SMDC Planning Reference –	DOC/2025/0091
Site Name –	Cellarhead Sub-Station Access Road BESS
Summary of proposals -	BESS Development adjacent to Cellarhead Sub-Station
Consultation Note Subject –	Materials Management Plan (MMP)
Planning Case Officer –	Lisa Li
Landscape Comments Prepared By –	Stuart Ryder of Ryder Landscape Consultants
Date of site visit —	No visit necessary as attended Site on previous occasions
Note Revision	No Rev – Original note dated 15/2/26
Summary of comments –	
From a landscape perspective: • The principle of re-using site-won material is supported. • The bund form and gabion strategy are acceptable in concept but remain visually engineered. • Soil handling and reinstatement detail requires further definition to ensure long-term landscape quality by keeping good quality topsoil for the bunds. • Drainage–geology relationships require clarification to avoid landscape management issues. • Gabion stone importation and traffic implications should be explicitly confirmed with the Applicant as there is a conflict between drawing and MMP information.

Cellarhead Access Rd BESS – Materials Management Plan Discharge Application

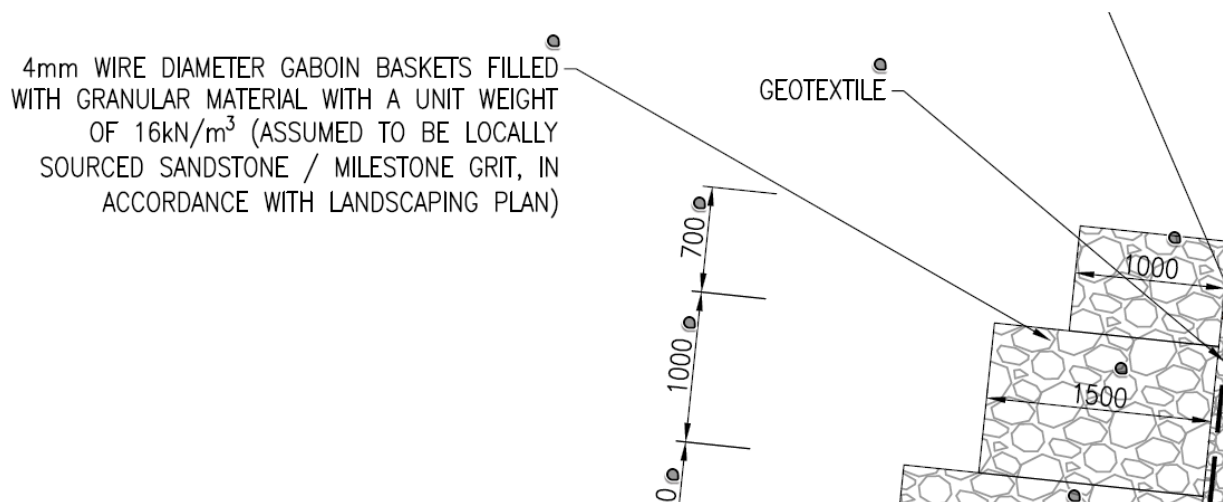
The clear recommendation is that any infiltration features need to be over the Chester Formation strata, this is the sandstone rock found on part of the Site. The SuDS basin excavated for the sub-

station in the NW of the Site is shown to be underlaid by glacial till (see Phase 2 of the earthworks diagram). Will this infiltration feature work?
